REMARKS

The following remarks are offered in response to the Office Action of December 14, 2004. Reconsideration and a Notice of Allowance is respectfully requested.

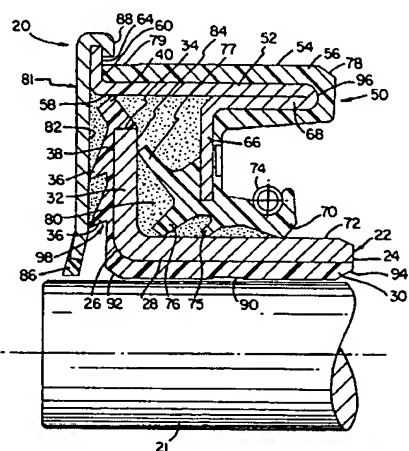
In the Office Action, the drawings were objected to as failing to show the recited first, second, third, fourth and fifth elastomeric lips. The specification was also objected to as not providing proper antecedent basis for these recited terms. Finally, claims 1-66 were objected to for the same reasons.

Claims 1, 5-6, 10-11, 15, 17, 22, 24, 27, 29, 39-40, 44-45, 49 and 51 were cited in the Office Action as having indefiniteness issues. Specifically, the phrases “generally radially inward” (from lines 8-9 of claim 1) and “generally radially outward” (from line 11 of claim 1) were identified as being indefinite. The Office Action inquires, “generally radially inward and outward to what other structure?”

Applicant respectfully disagrees with these objections. For example, paragraph [0047] of the published application discusses a "main sealing lip 70" and paragraph [0025] makes clear that this lip is an "elastomeric, main sealing lip." Paragraph [0043] discusses a "perimeter lip 40" and paragraph [0021] makes clear that this lip is an "elastomeric perimeter lip." Paragraph [0043] discusses two "face lips 36" and paragraph [0020] makes clear that these lips are "elastomeric face lips." Paragraph [0048] discusses a "mid-sleeve dust lip 75," a "forward sleeve dust lip 76," and a "case flange dust lip 77." Paragraph [0048] goes on to state that the "elastomeric coating 56, the main sealing lip 70" and the dust lips 75, 76, 77 can be "integrally formed ... in a single injection molding operation." Thus, at least seven "elastomeric lips" are discussed in the specification and specifically identified in Figure 1 by reference numbers. Also, the abstract discusses elastomeric lips and U.S. Patent 6,186,507, which was the original application from which the current pending application claims priority, issued with three independent claims reciting elastomeric lips.

Claim 1 goes on to state that the “first elastomeric lip extend[s] generally between a portion of the first flange and a portion of the faceplate and includes a base and a tip.” The face lips 36, which are discussed in detail in the specification, are the only elastomeric lips of the seal depicted in FIG. 1 that extend between the first flange and the face plate and include a base and tip.

Claim 1 further states that the “tip [of the elastomeric lip] is oriented generally radially inward.” As is clear from FIG. 1, the tip of each face lip 36 is oriented radially inward. Thus, it is clear that the language “generally radially inward” is not indefinite when considered with claim 1 as a whole and in light of the application’s disclosure.
